RE: **Lot 24 Block 1 Volcano Cliffs Unit 22 SAD 228**
8000 Agua Fria Ct. NW
Grading and Drainage Plan
Engineers Stamp Date 5/12/2020 (D10D003N24)

DRAINAGE AND TRANSPORTATION INFORMATION SHEET (REV 11/2018)

| PROJECT NAME: | VOLCANO CLIFFS 8000 AGUA FRIA COURT NW PULTE ID 26 | |
| SHEET TITLE: | GRADING AND DRAINAGE PLAN | |

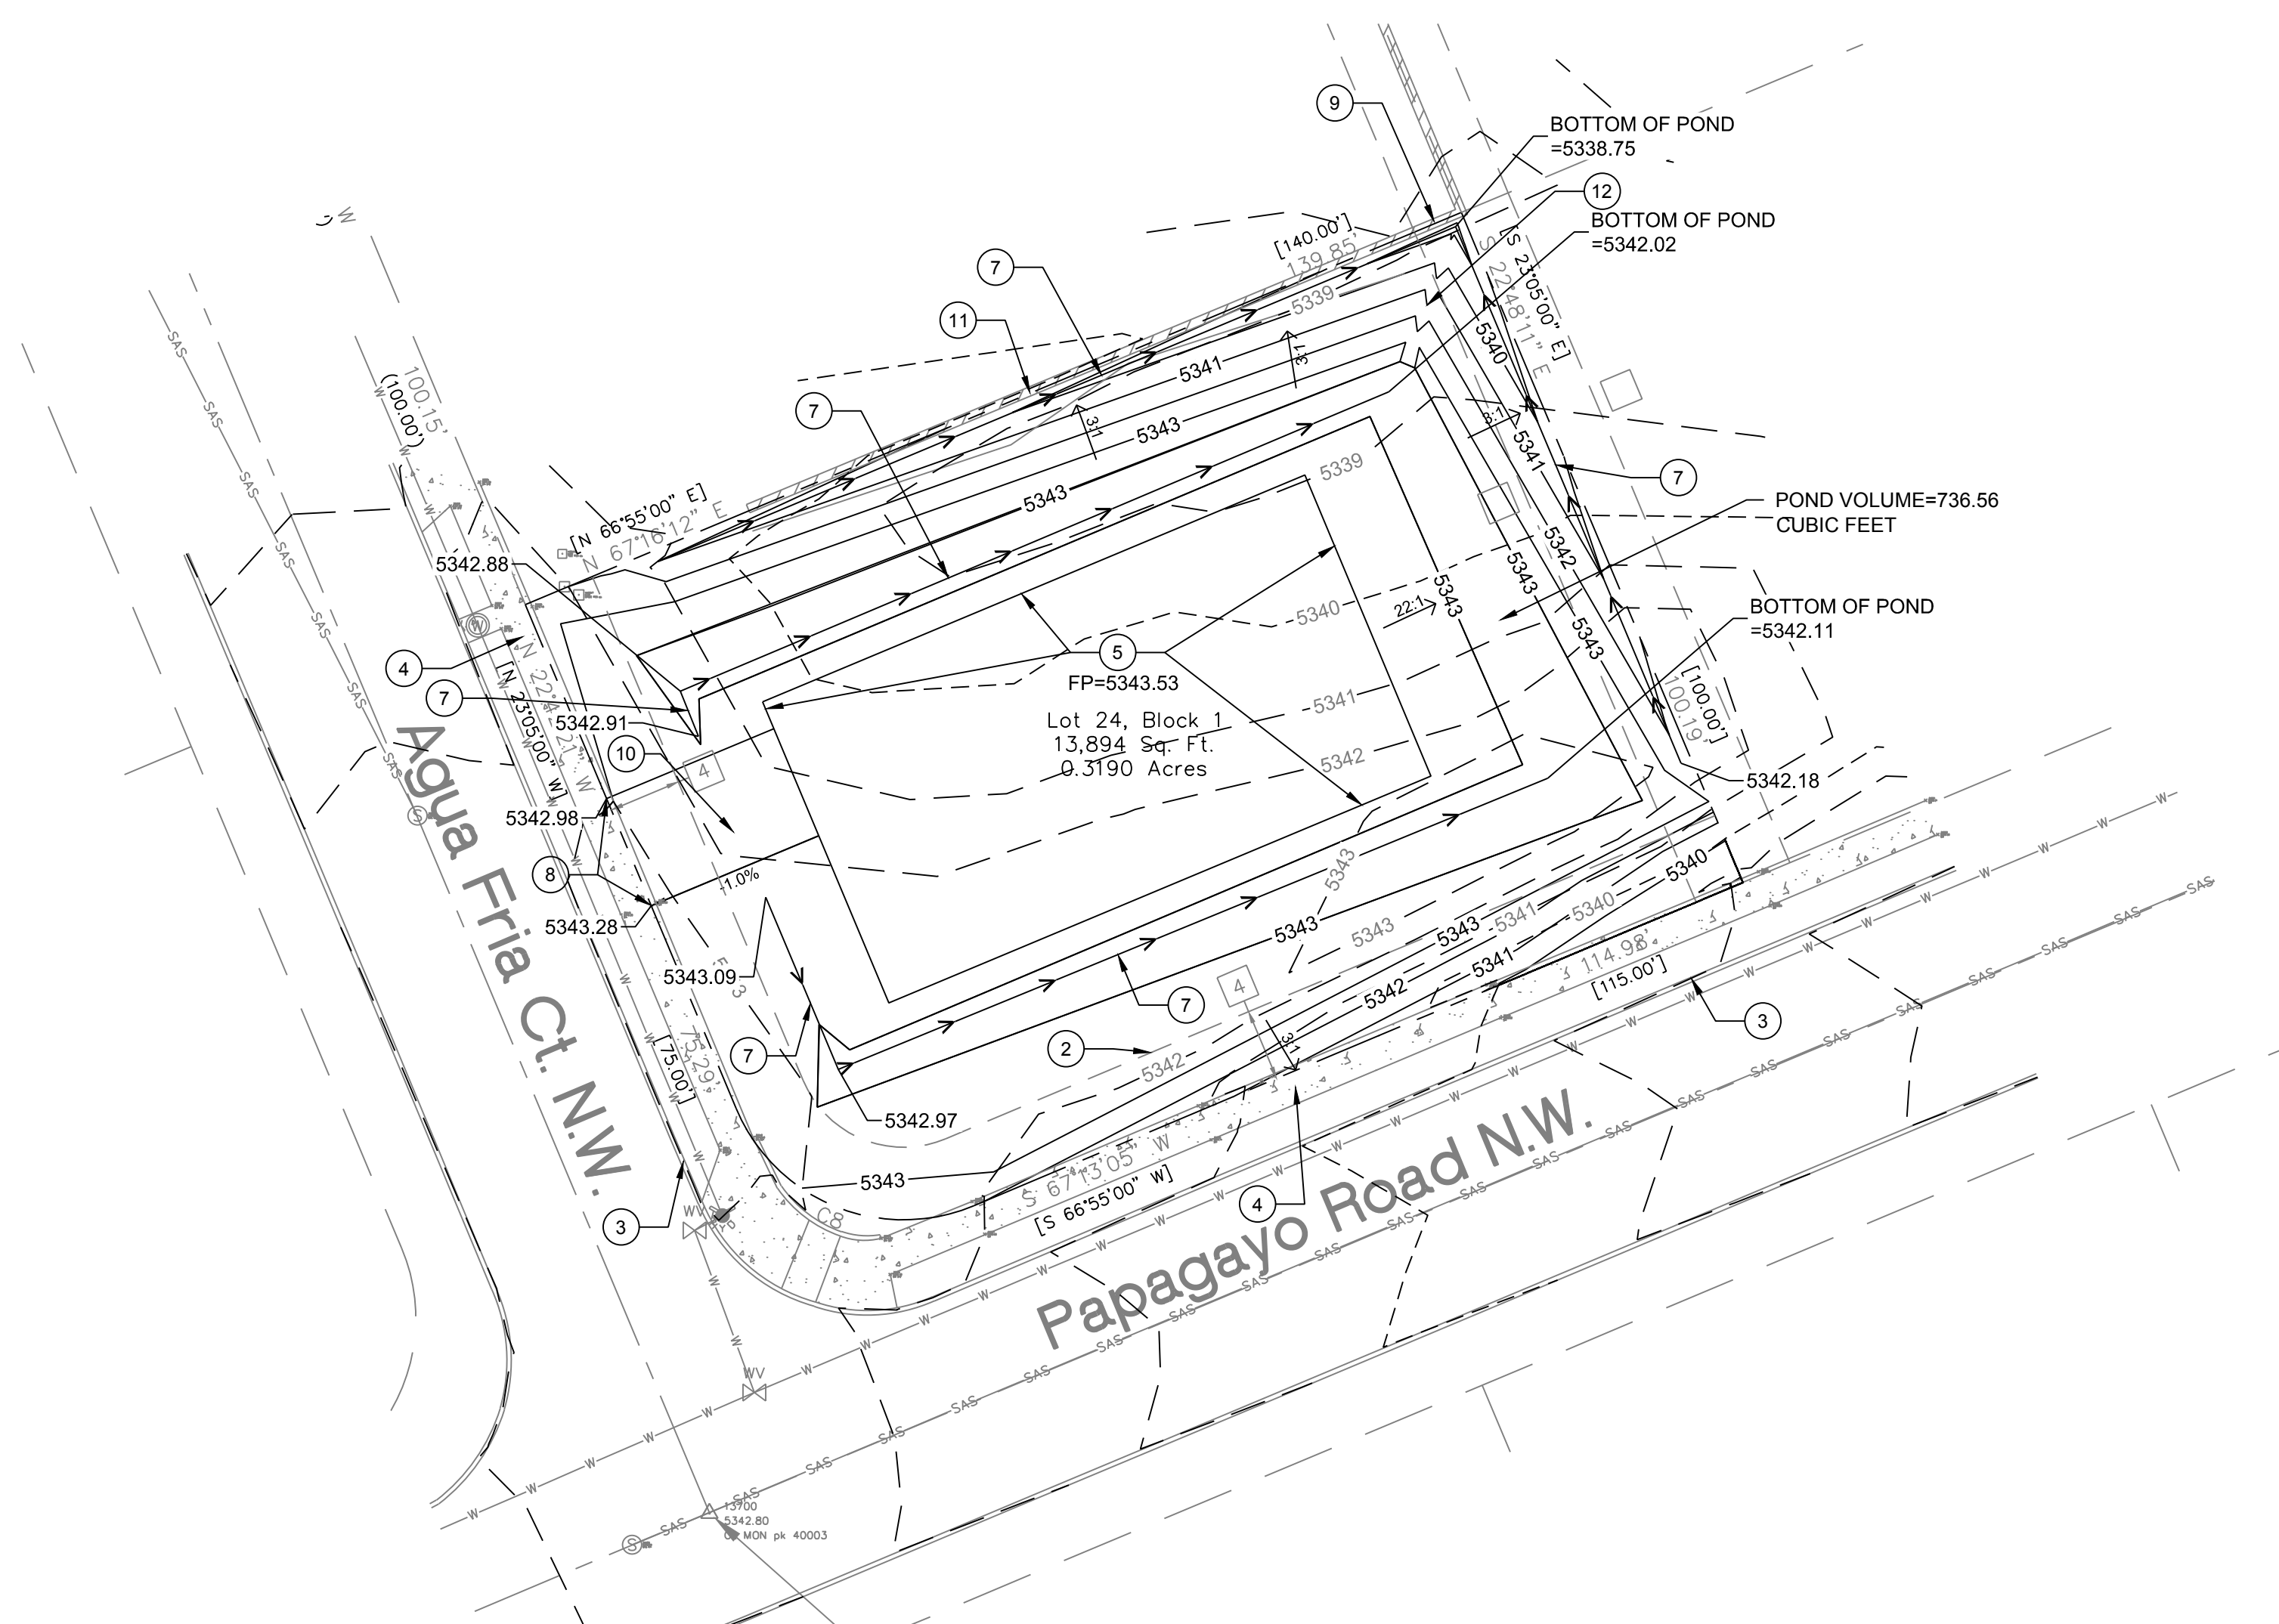
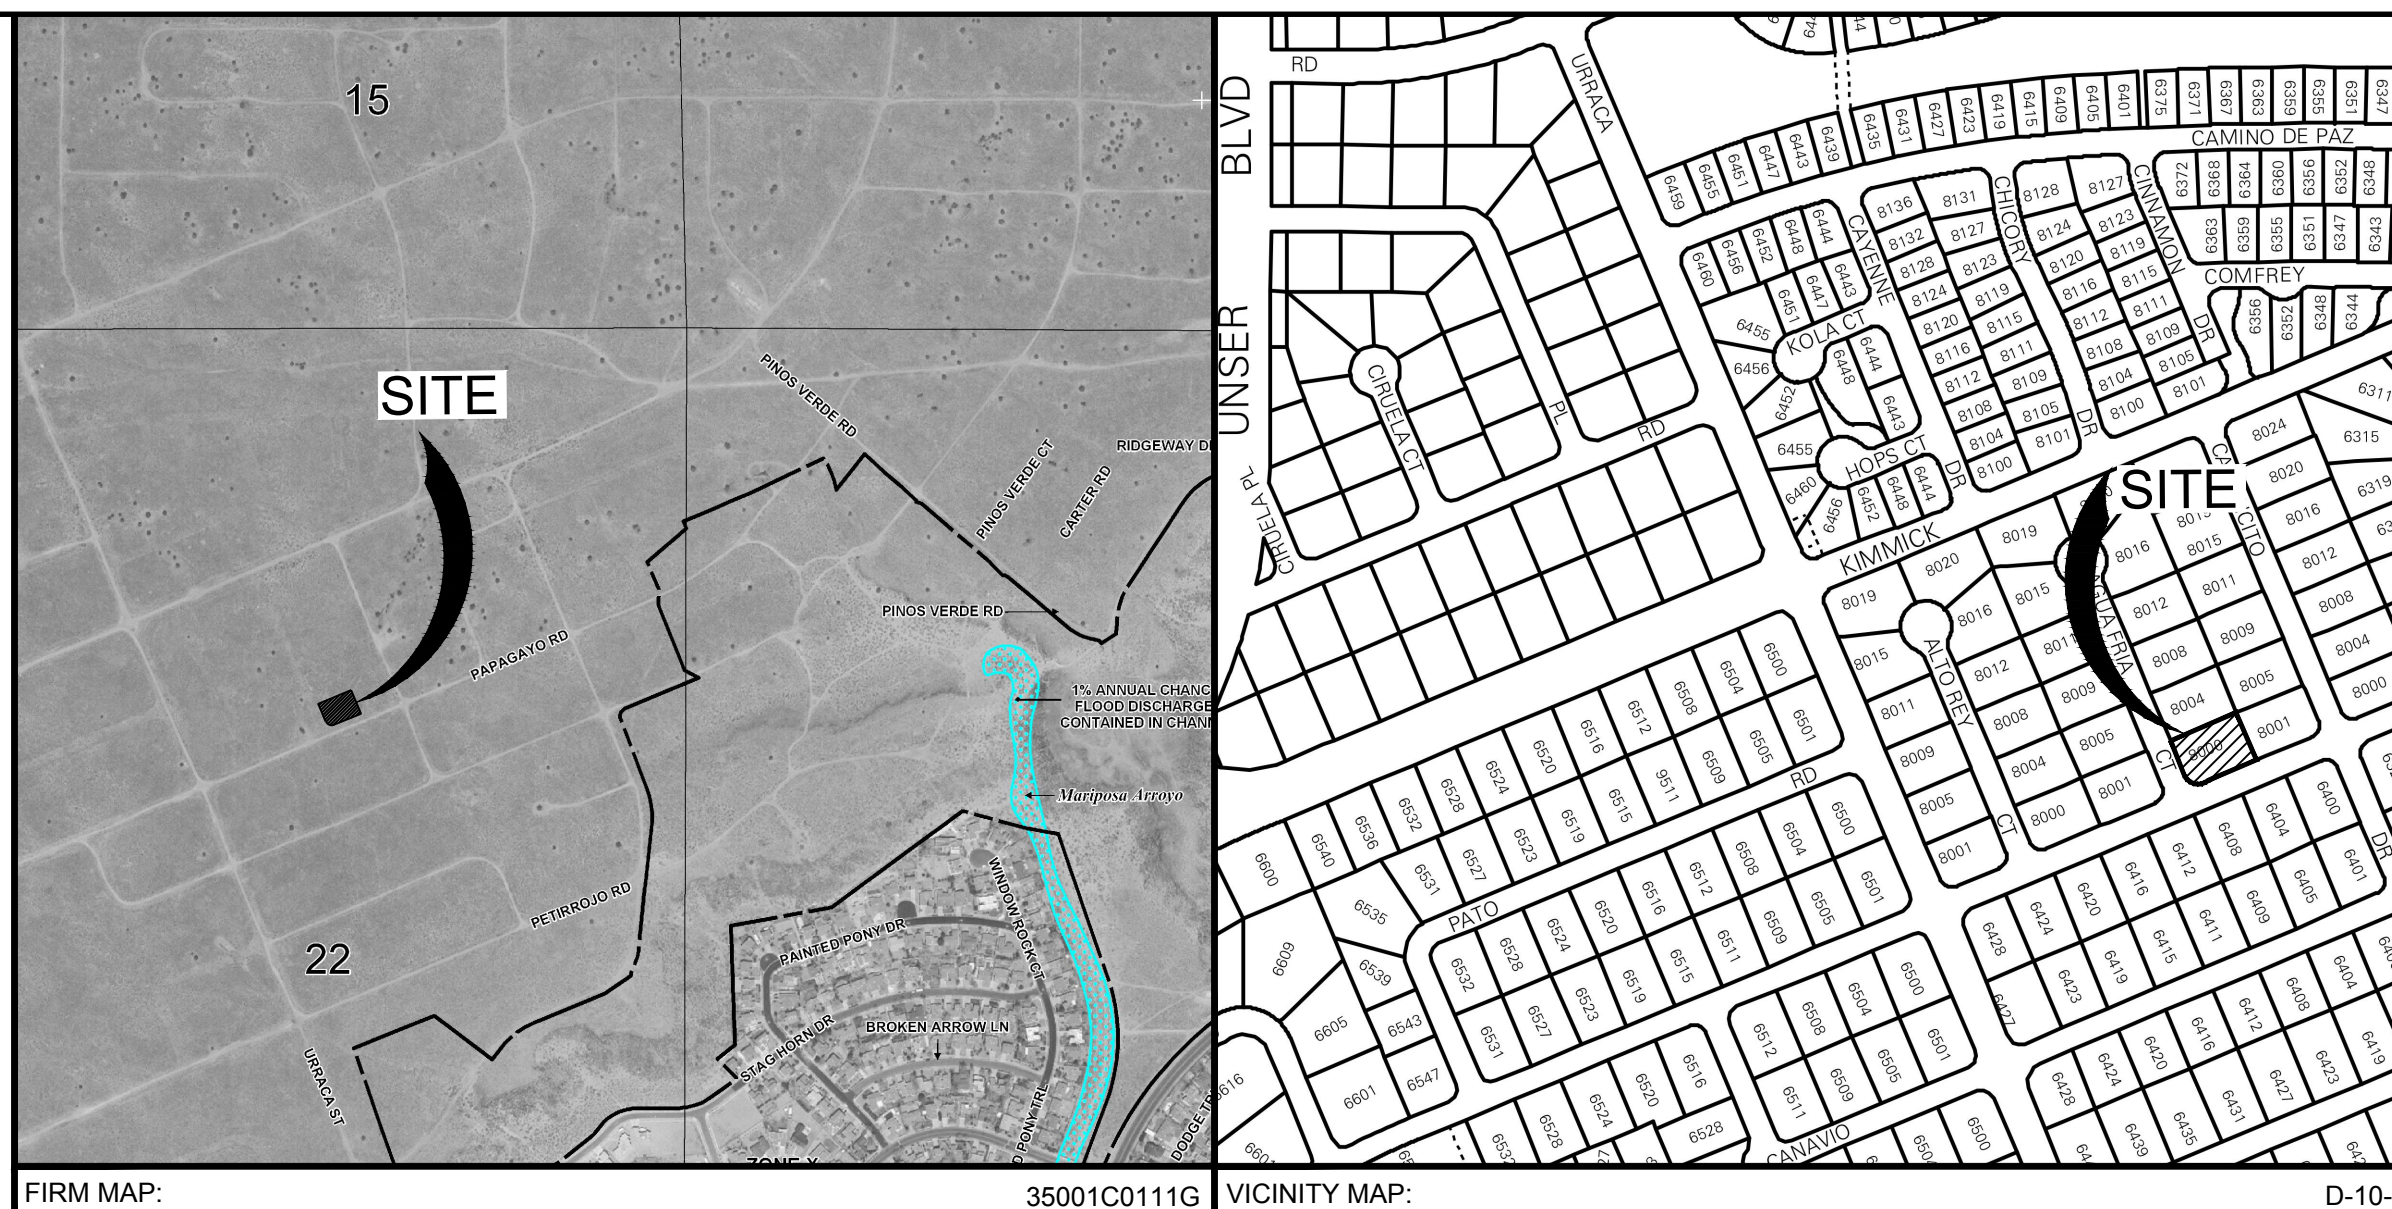
Based upon the information provided in your submittal received 6/17/2020, this plan is approved for Grading Permit.

Prior to Building permit approval a Pad Certification will be required, provided by the Engineer or a registered Land Surveyor.

Reiterate to the Owner/Contractor that a separate permit for a garden/retaining wall must be obtained with the approved G&D plan and Pad Certification. **Also, if a swimming pool is to be placed the grading and drainage plan will change and will need to be resubmitted.**

Prior to Certificate of Occupancy release, Engineer Certification per the DPM checklist will be required.
